REVIEW OF THE CRYOGENIC BY-PASS FOR THE LHC DS COLLIMATORS

**ELECTRICAL CIRCUIT MODIFICATION,
INCLUDING OPERATIONAL
CONSIDERATIONS**

PRESENTED BY A. SIEMKO

Bus bar routing in the SSS

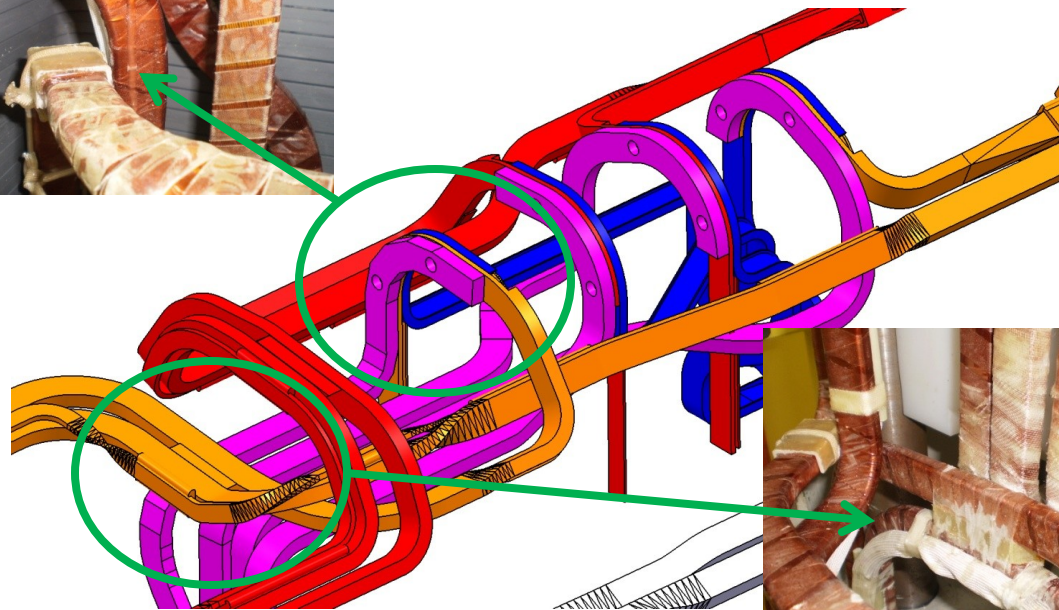
- Avoid COMPLEX ROUTING
 - busbar partially filled in SnAg, continuity of the resistive circuit
 - i.e. see coil connections in the SSS quadrupole magnets, some parts manually filled badly compromising the soldering process (pics available by tomorrow).

Reuse of validated designs like central part of the busbars

Dipole line MQ double lyra
Kapton damaged

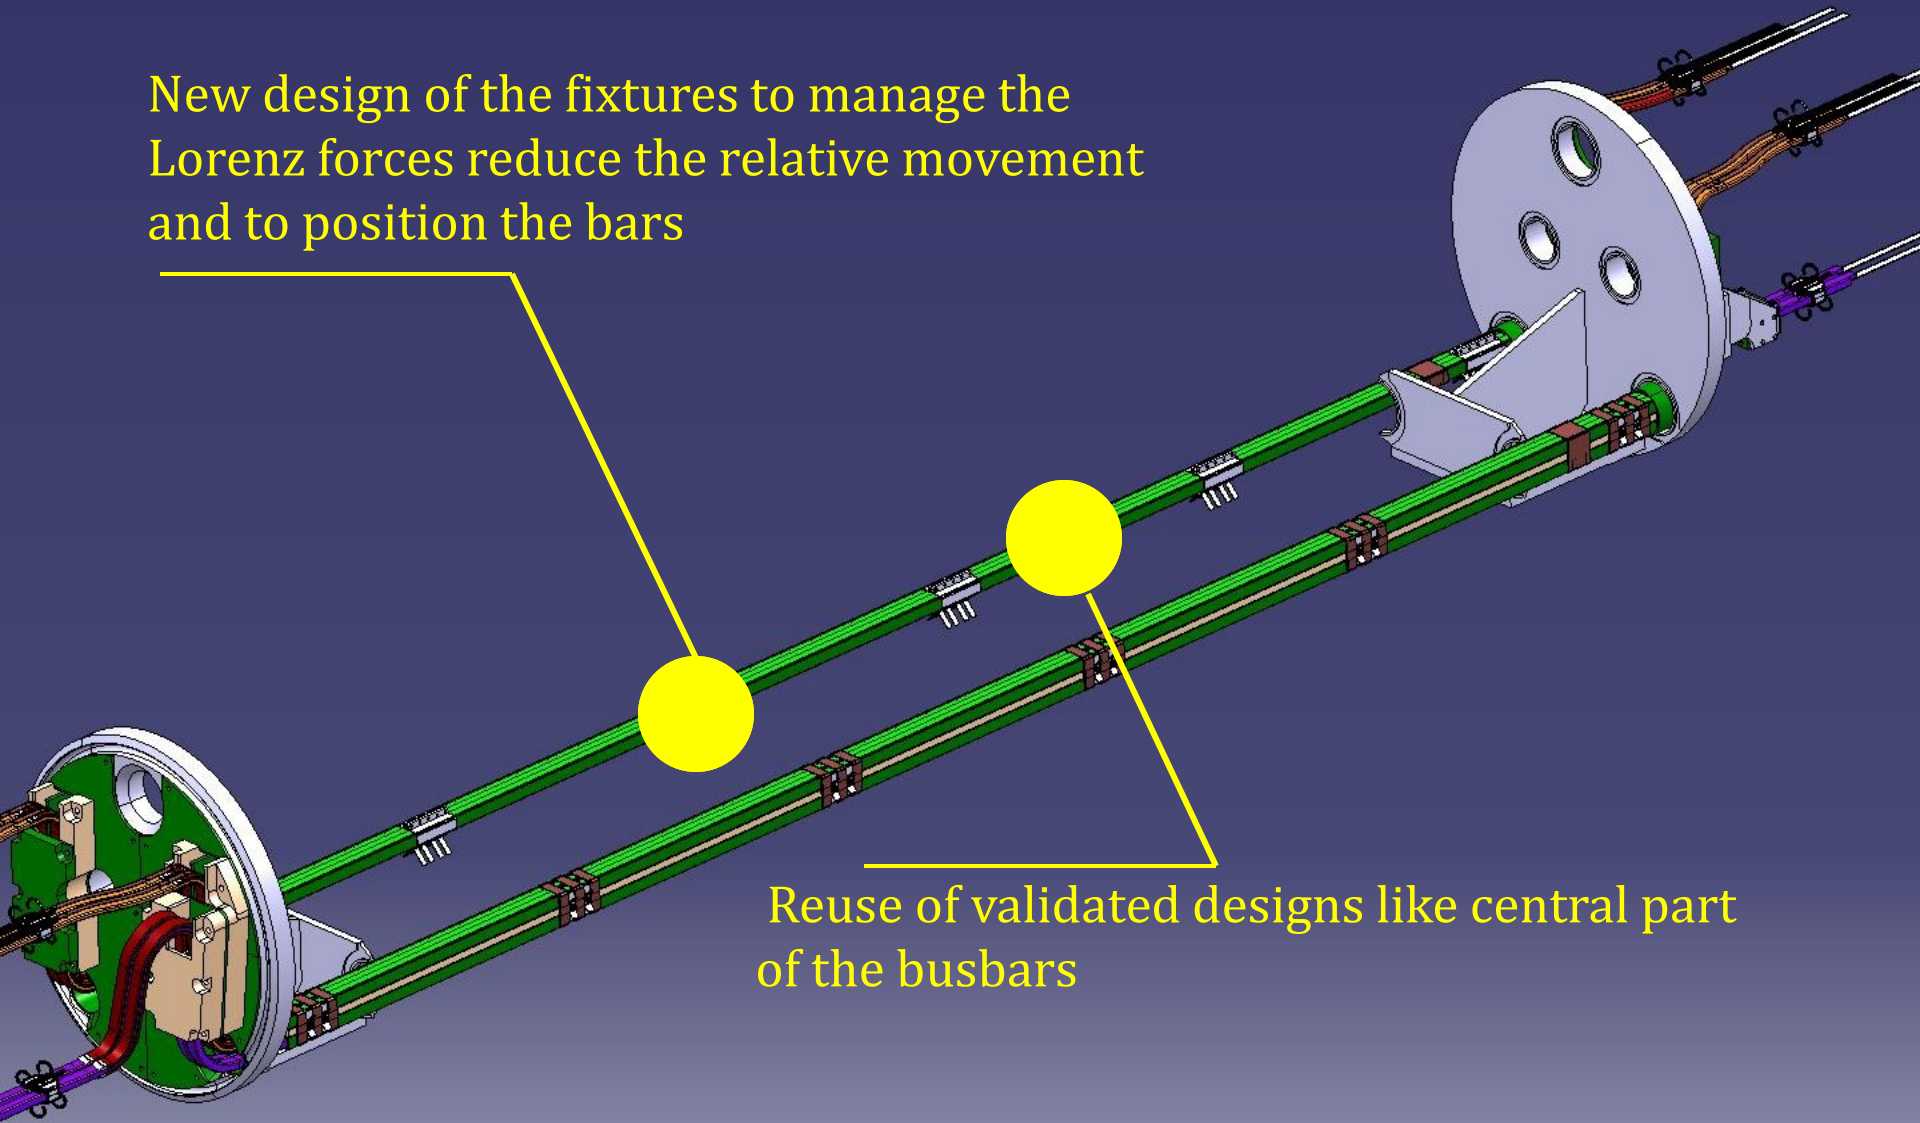
- Polyimide exposed to friction (insulation concerns)
- Busbars locally positioned with INADEQUATE COMPONENTS
 - Shape and material (sharp angles, G11, examples)

Insulating layer (PEHD, rayton)
behind the Quad lyras

design
modified

insulating protection
(with smooth profiles)
M1+3 and M2

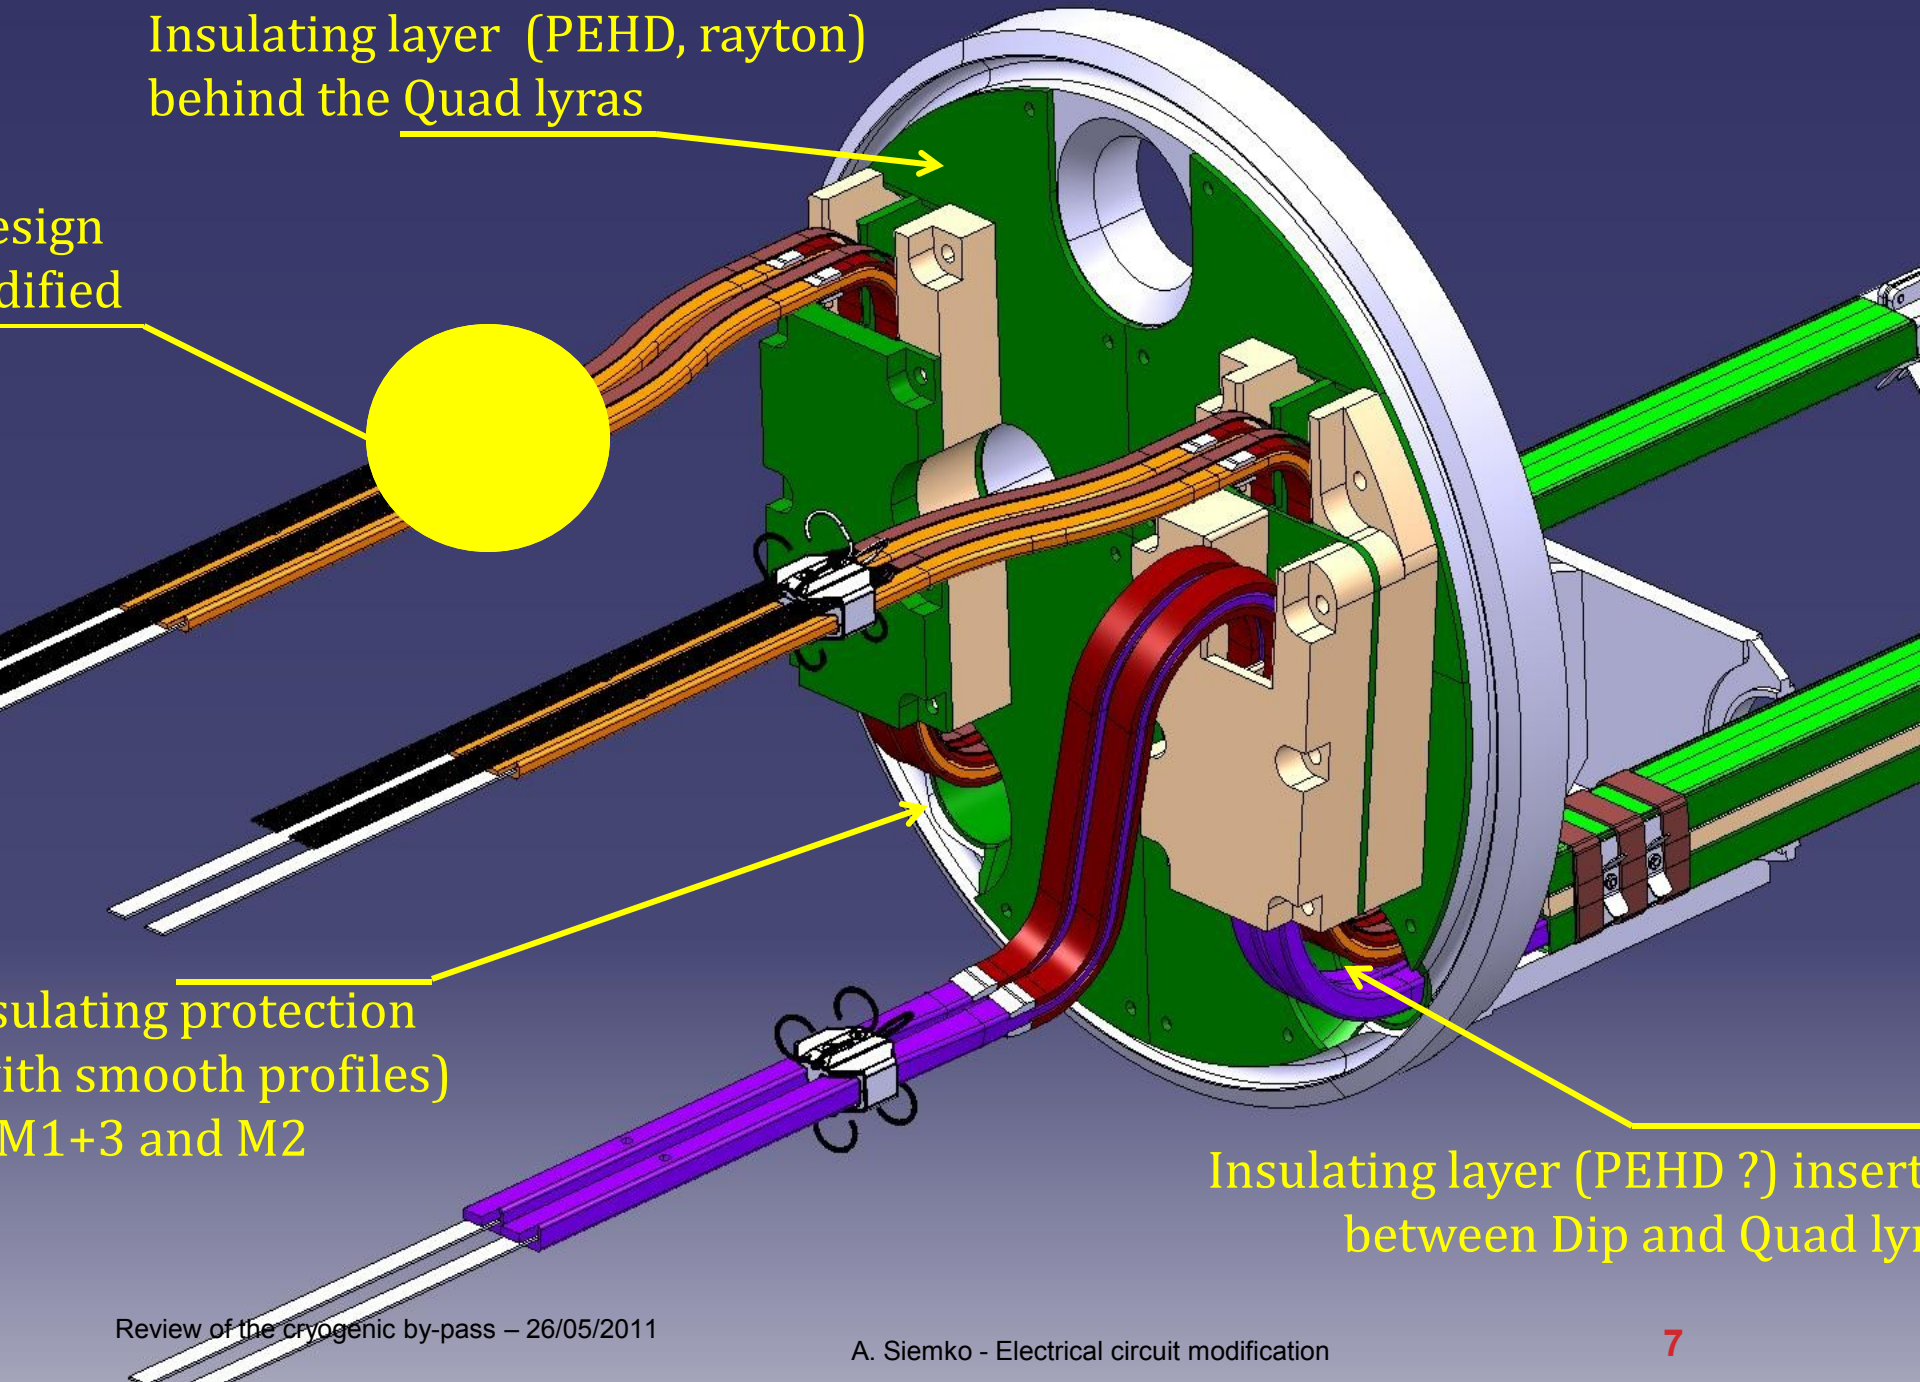
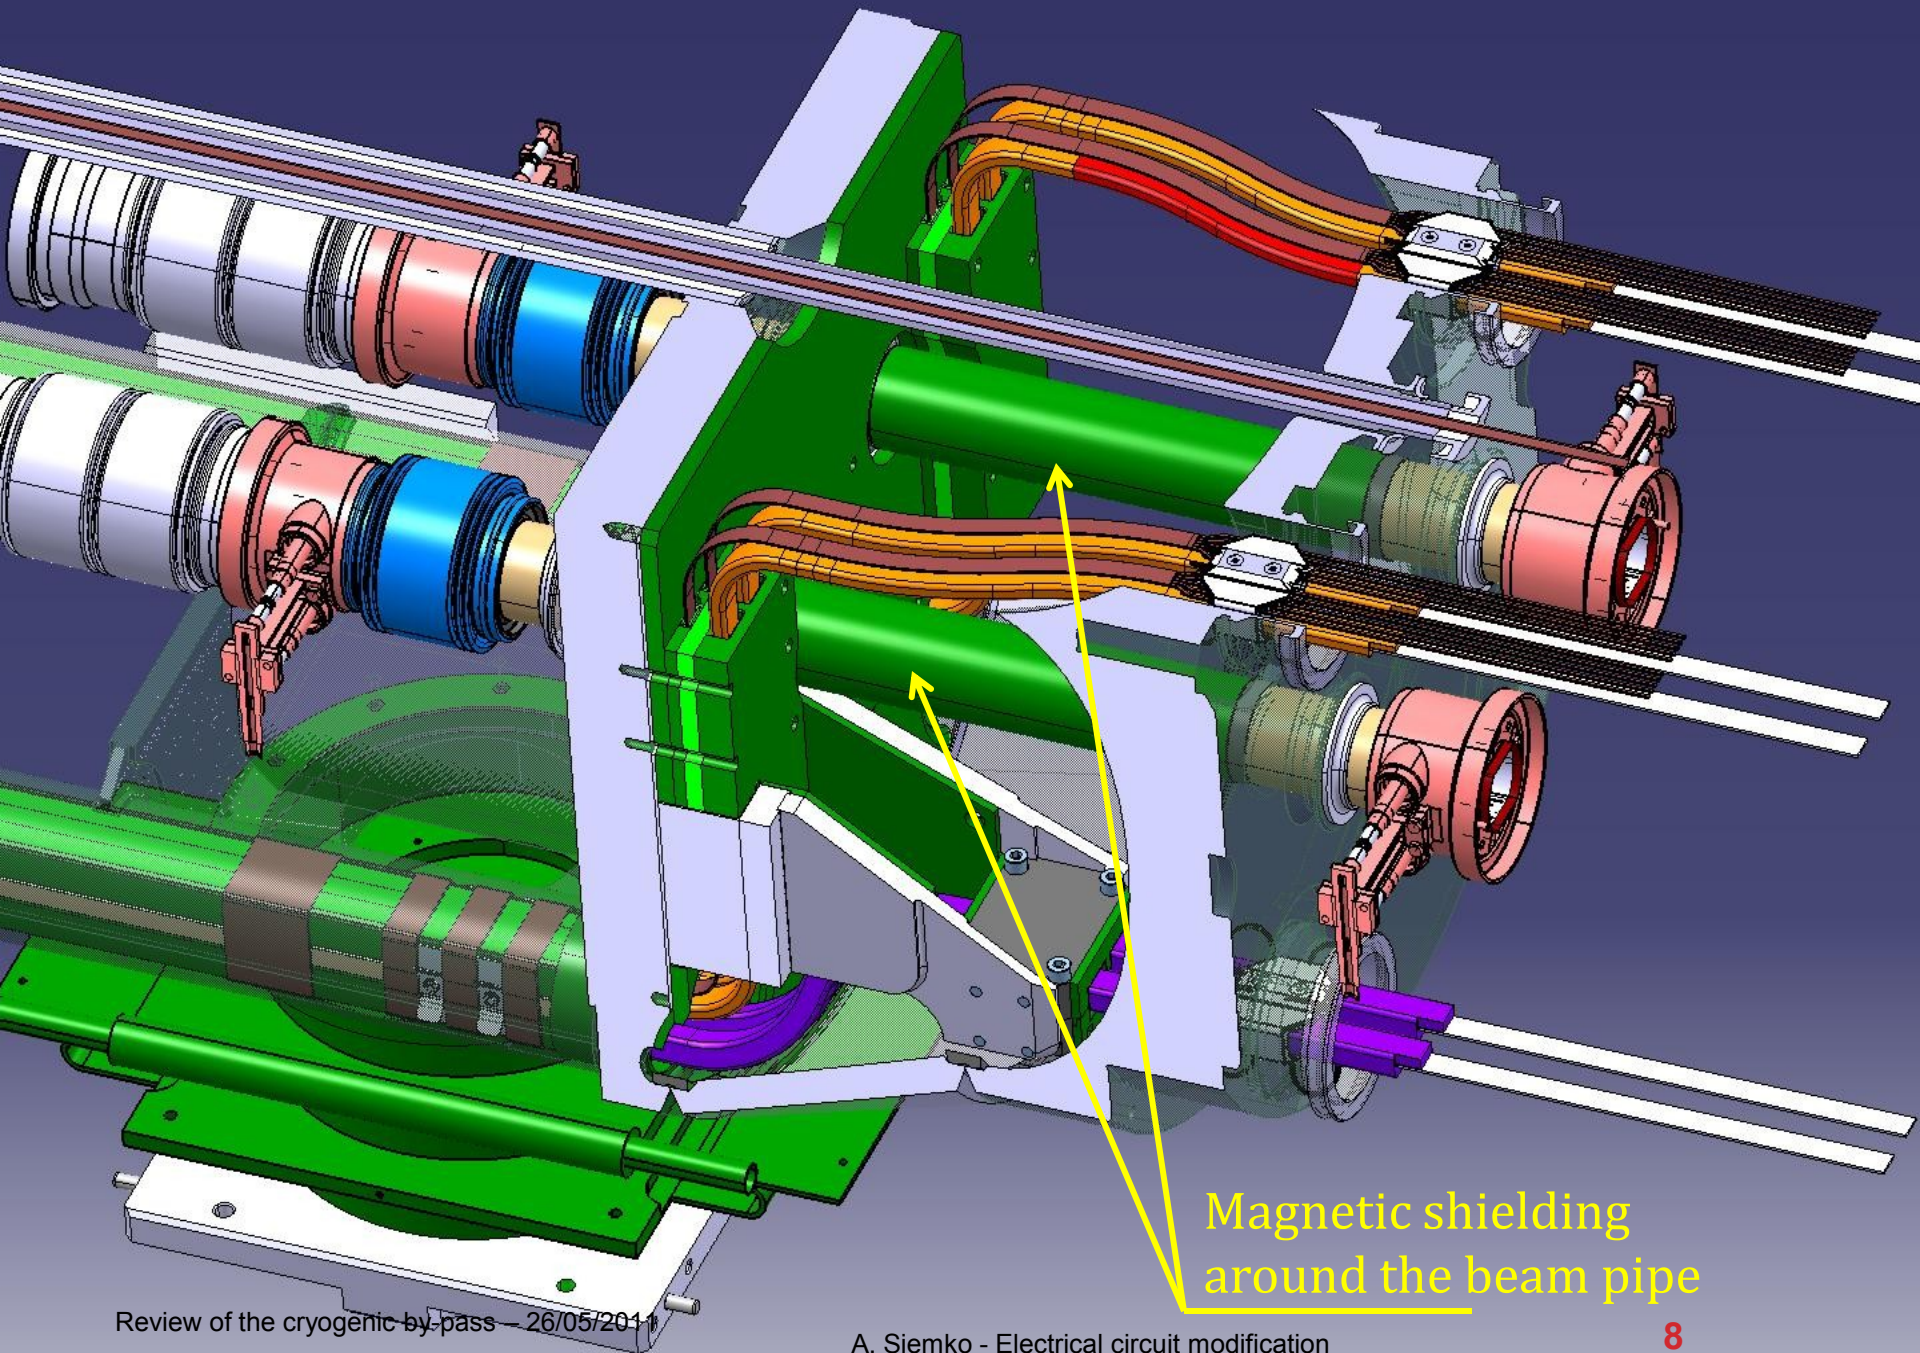
- Assembly (examples)
- Standard components to be improved (spider, supports in the pipe M1+3 and M2).
- Adequate dimensioning and positioning of the components to compensate the Lorentz forces (mainly M1+3).

New design of the fixtures to manage the Lorenz forces reduce the relative movement and to position the bars

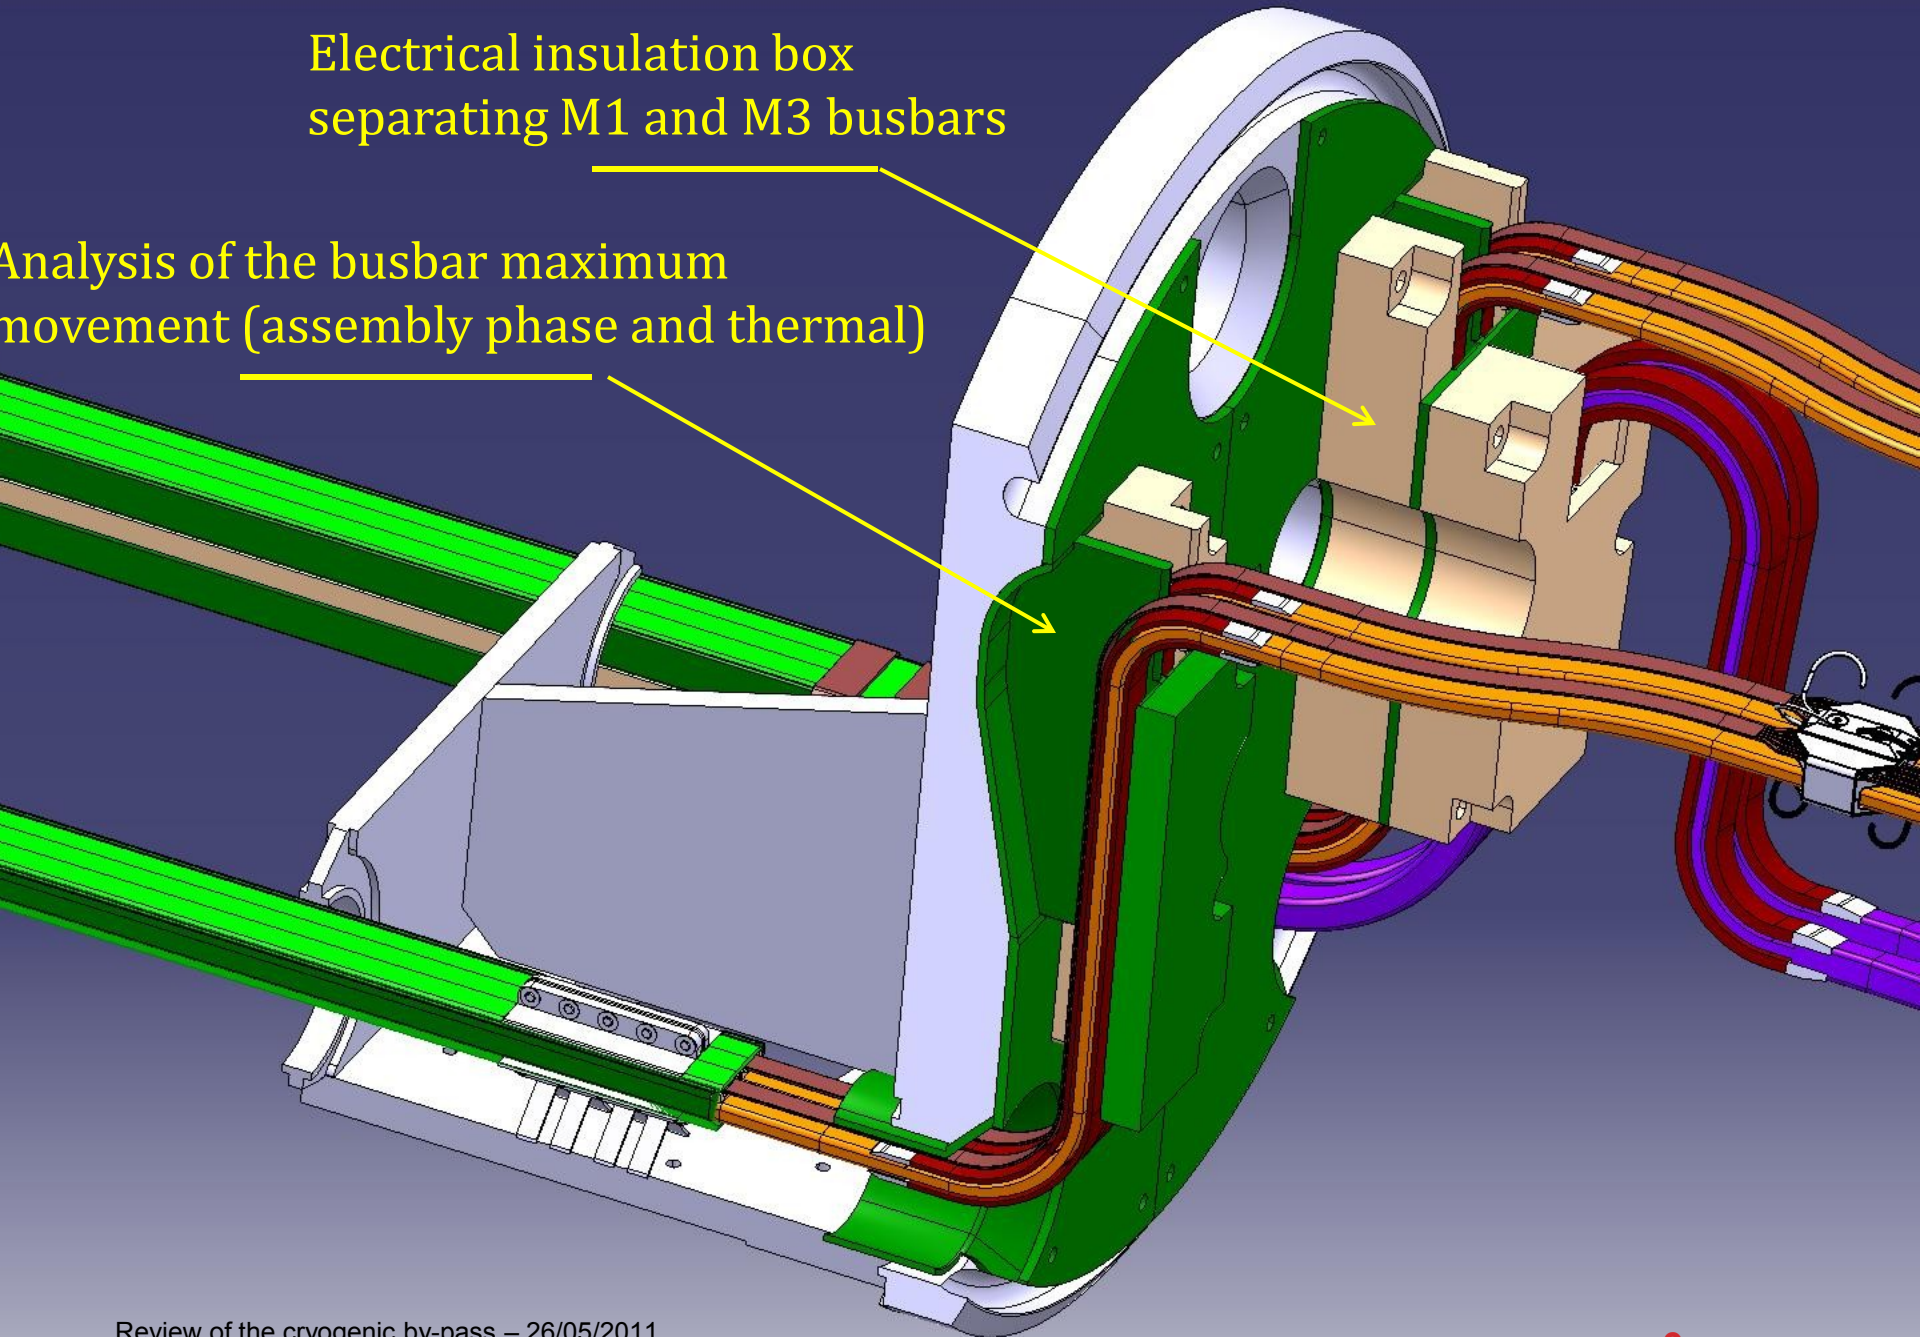
- Electromagnetic field interactions: busbars in the vicinity of the vacuum pipe (calculation required to estimate the influence on the beam).
- Busbar movements (single bar) vs. the cryobypass structure

Insulating layer (PEHD ?) insert
between Dip and Quad lyras

Magnetic shielding
around the beam pipe

Electrical insulation box
separating M1 and M3 busbars

Analysis of the busbar maximum
movement (assembly phase and thermal)
